11/14/97	Plan revised to indicate pedestrian and bicycle safe grate GDI's.
DATE	REVISION
STATE OF HAWAII DEPARTMENT OF TRANSPORTATION HIGHWAYS DIVISION	
DRAINAGE PLAN	
VOLCANO RD. DRAINAGE IMPROVEMENTS	
Vicinity of Keau Town	
F.A. Proj. No. STP-011-2(30)	
Scale: 1"=40'	Date: Oct 1997
SHEET No. <i>HI</i> OF 6 SHEETS

DRAINAGE DETAILS
VOLCANO RD. DRAINAGE IMPROVEMENTS
Vicinity of Keaau Town
F.A. Proj. No. STP-011-2(30)
Scale: 3/4" = 1'-0"
Date: Oct 1997

STATE OF HAWAII DEPARTMENT OF TRANSPORTATION HIGHWAYS DIVISION
DRAINAGE DETAILS
VOLCANO RD. DRAINAGE IMPROVEMENTS Vicinity of Keaau Town F.A. Proj. No. STP-011-2(30)
Scale: 3/4" = 1'-0" Date: Oct 1997
SHEET No. H4 OF 6 SHEETS

DETAILS OF TYPE 61614P DRYWELL AT STA. 1063+00 LT.

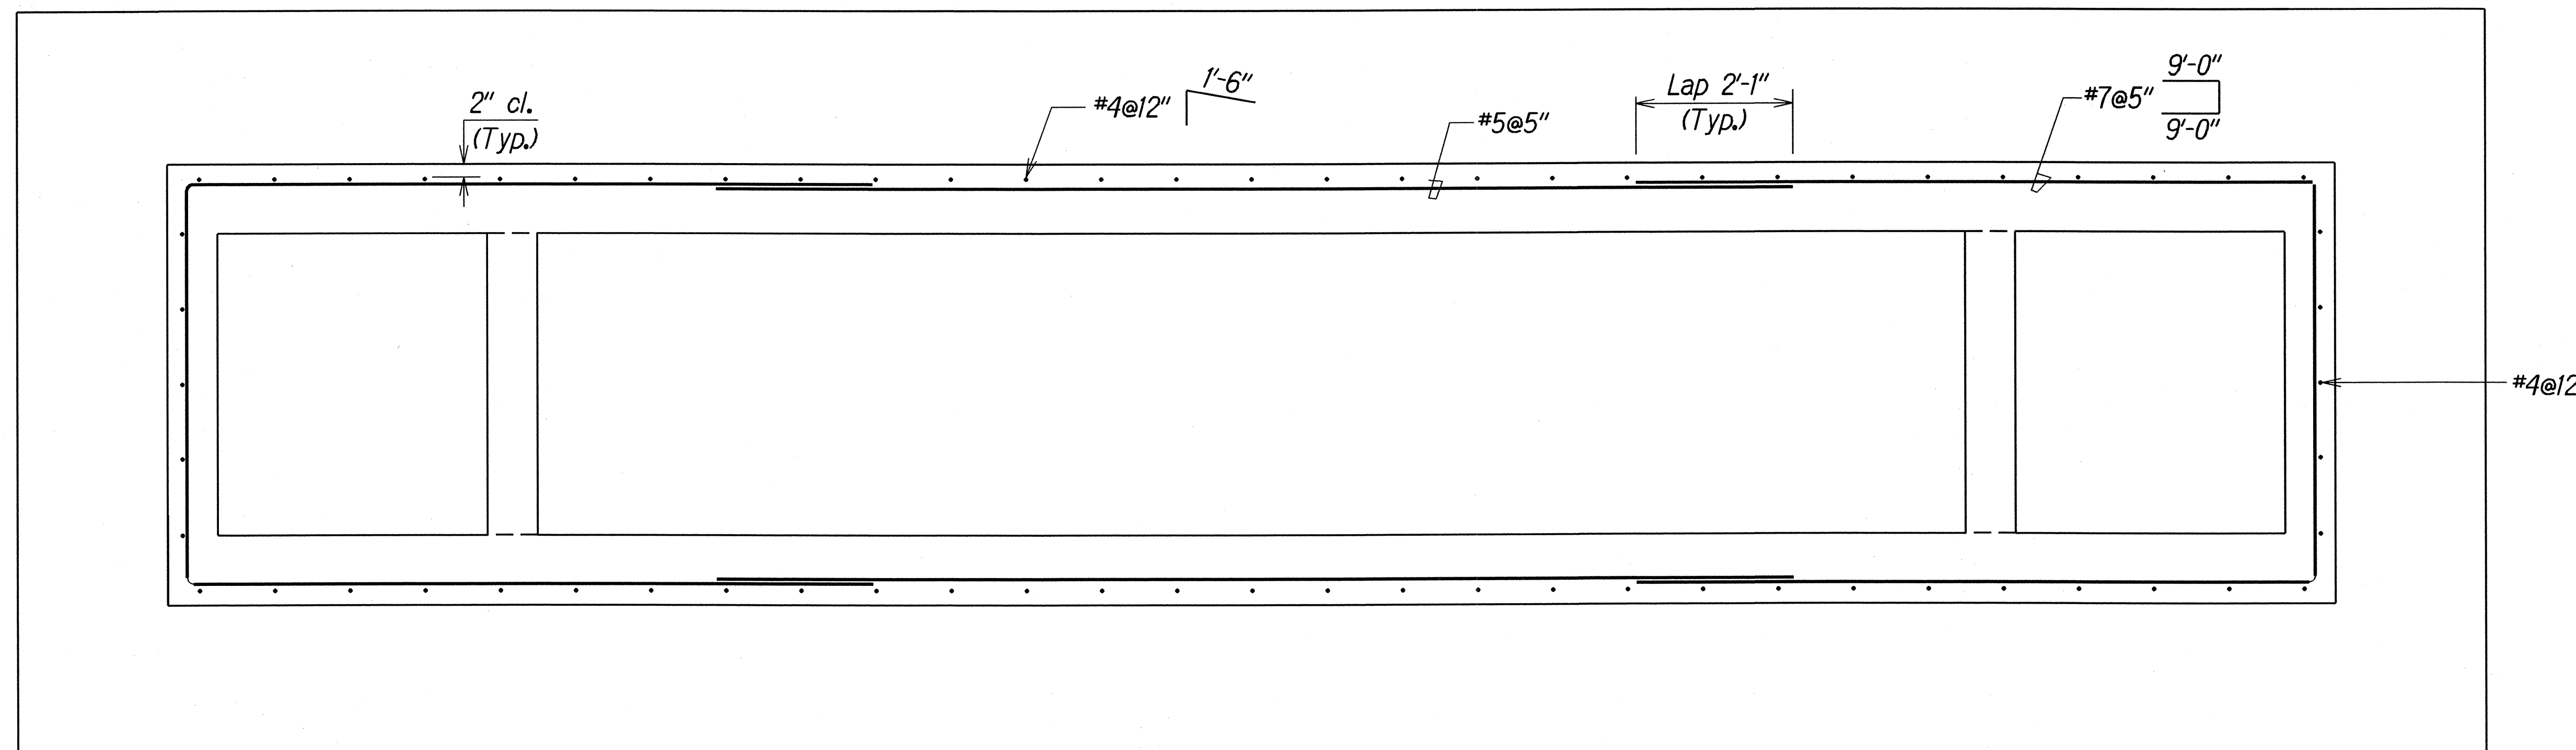
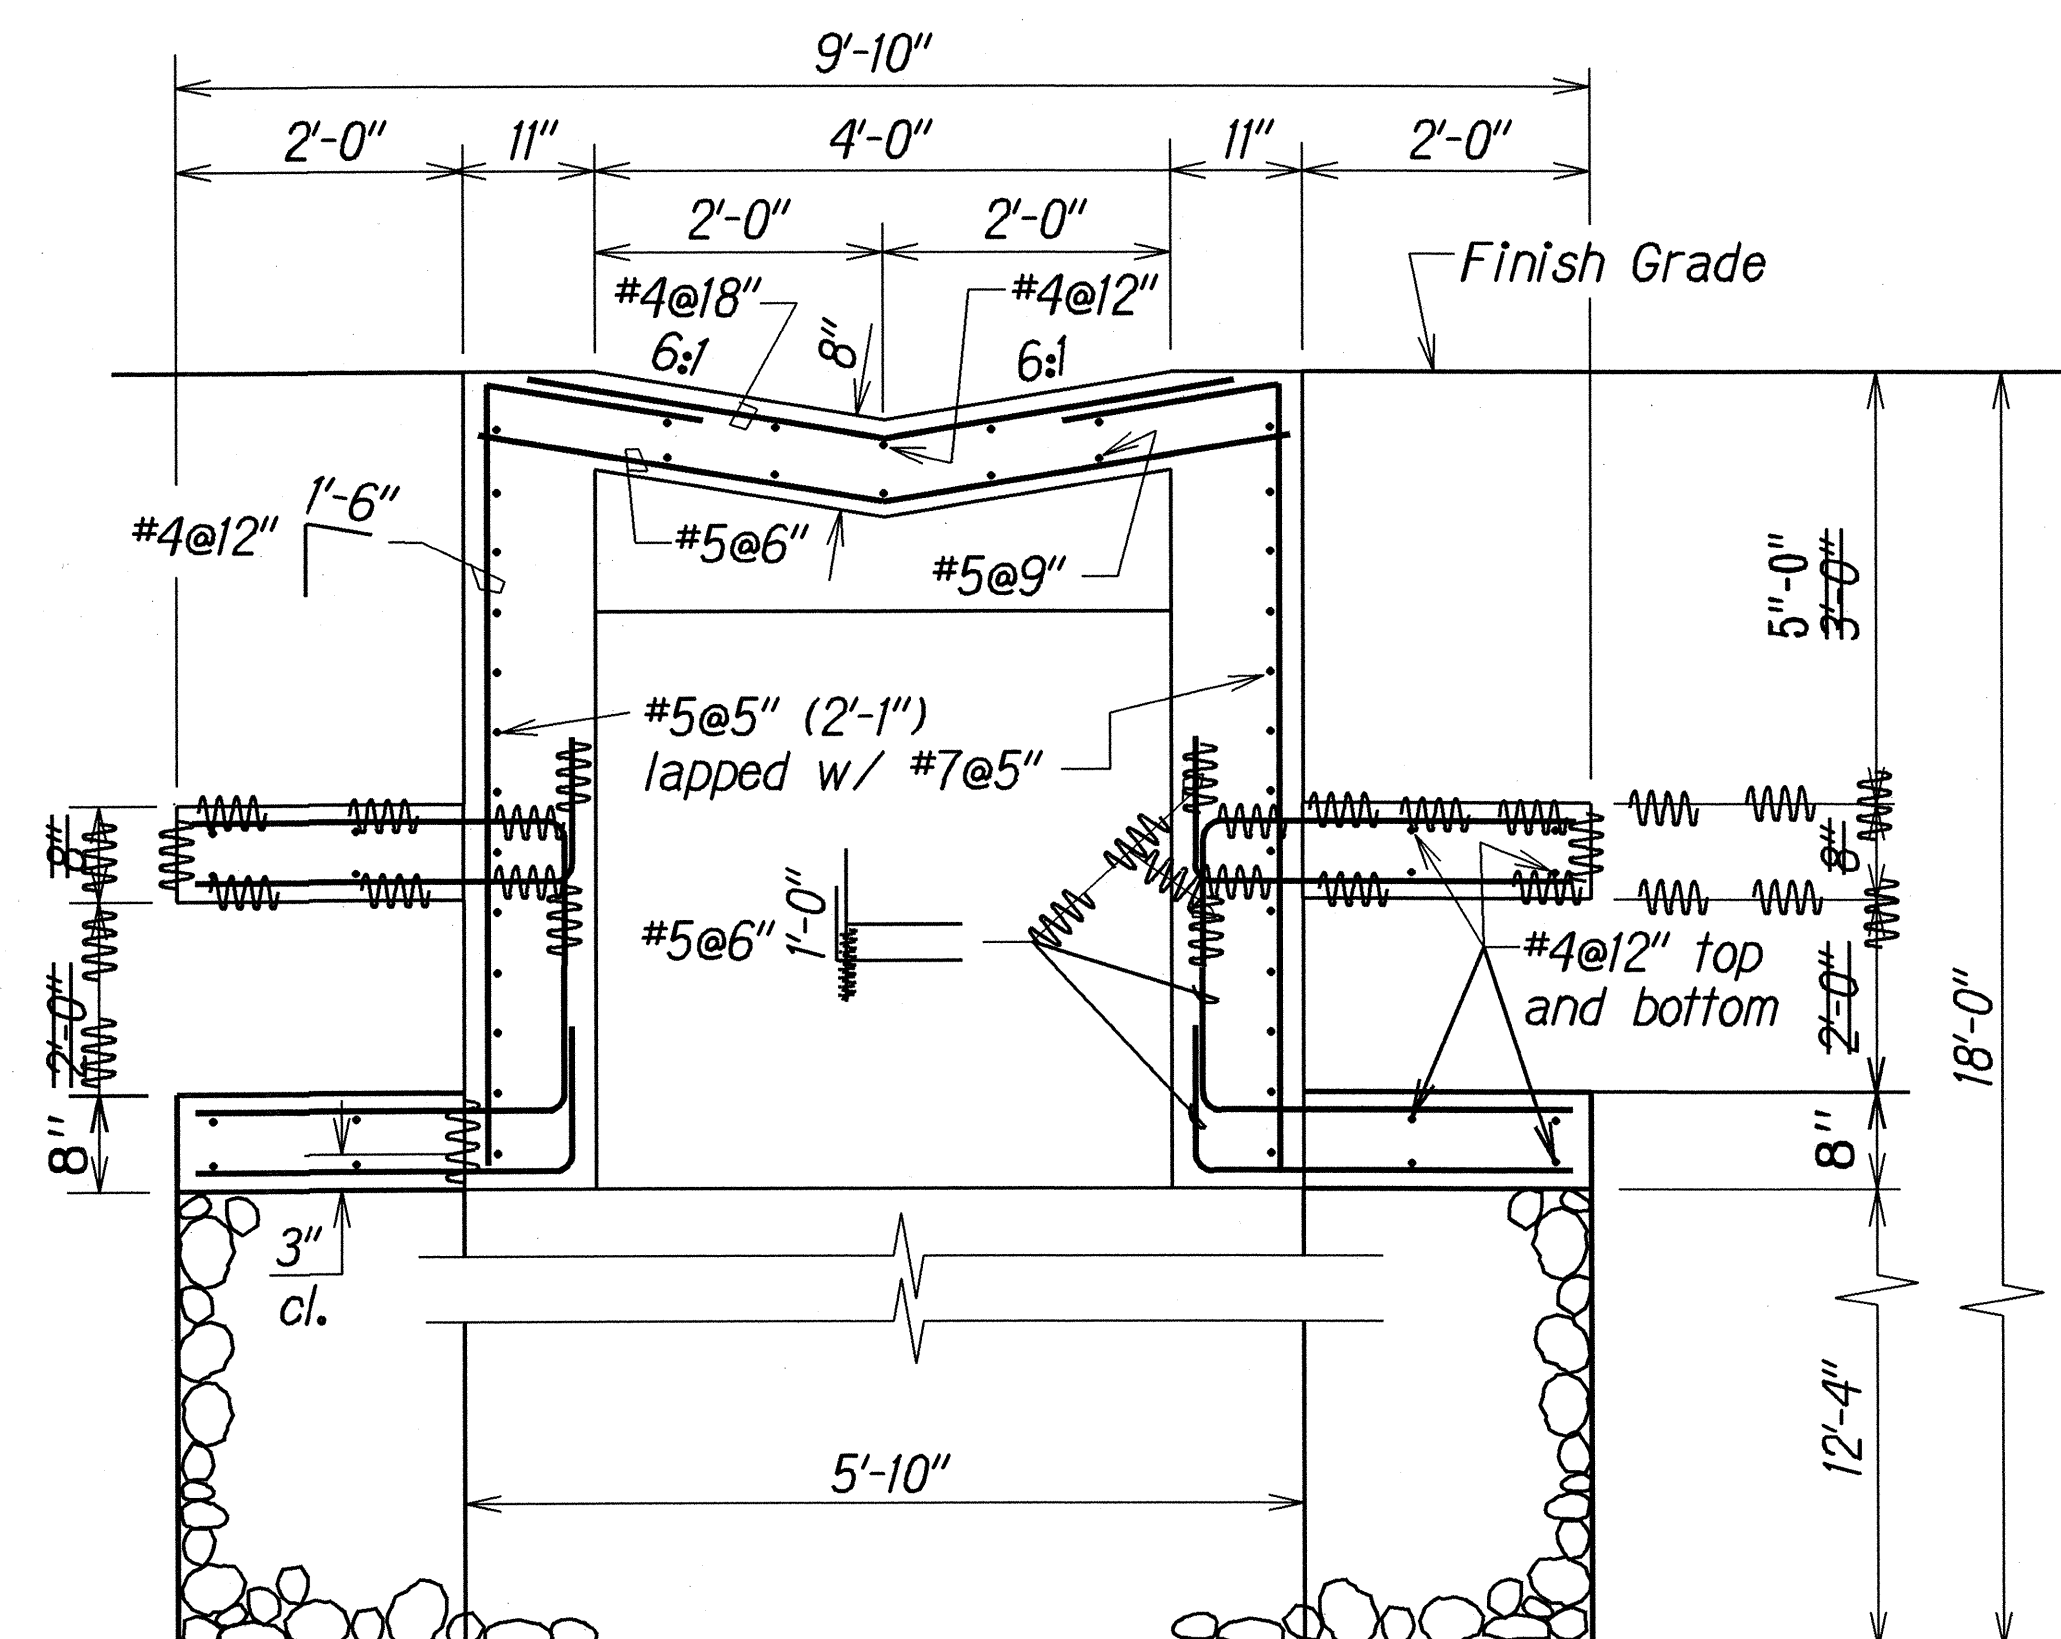
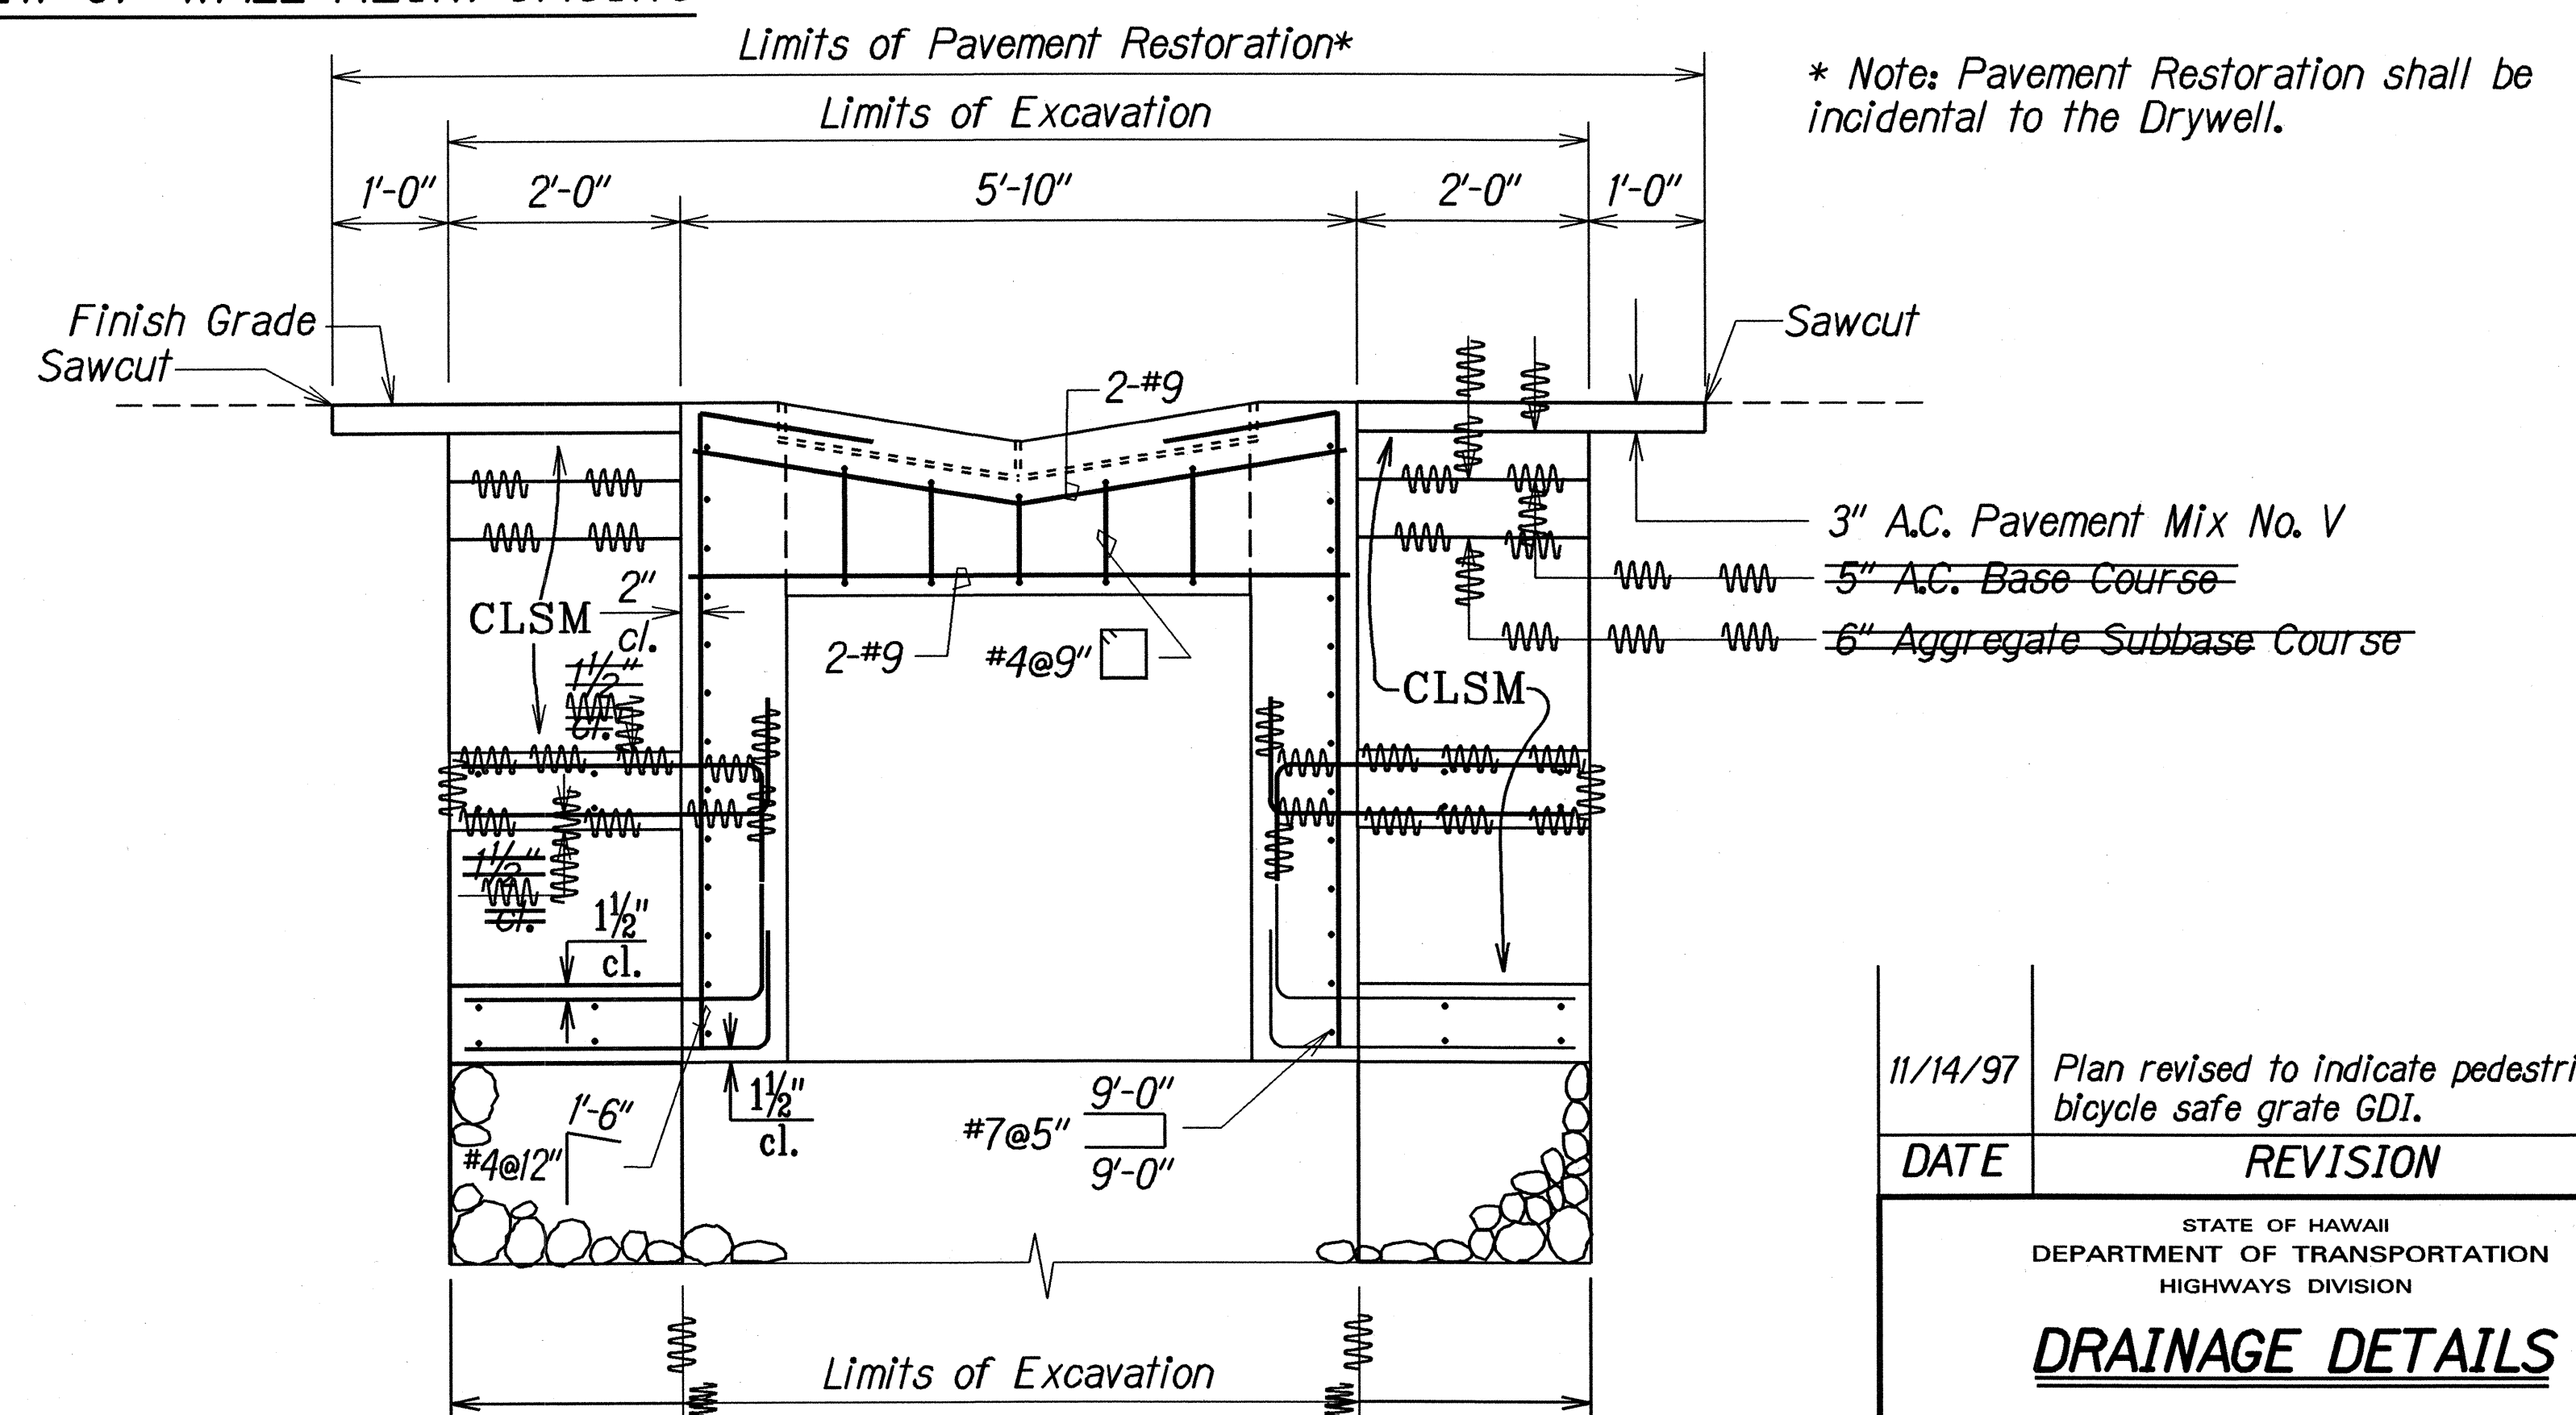
11/14/97	Plan revised to indicate pedestrian and bicycle safe grate GDI.
DATE	REVISION
STATE OF HAWAII DEPARTMENT OF TRANSPORTATION HIGHWAYS DIVISION	
DRAINAGE DETAILS	
VOLCANO RD. DRAINAGE IMPROVEMENTS	
Vicinity of Keaau Town	
F.A. Proj. No. STP-011-2(30)	
Scale: 3/4" = 1'-0"	Date: Oct 1997
SHEET No. H5 OF 6 SHEETS
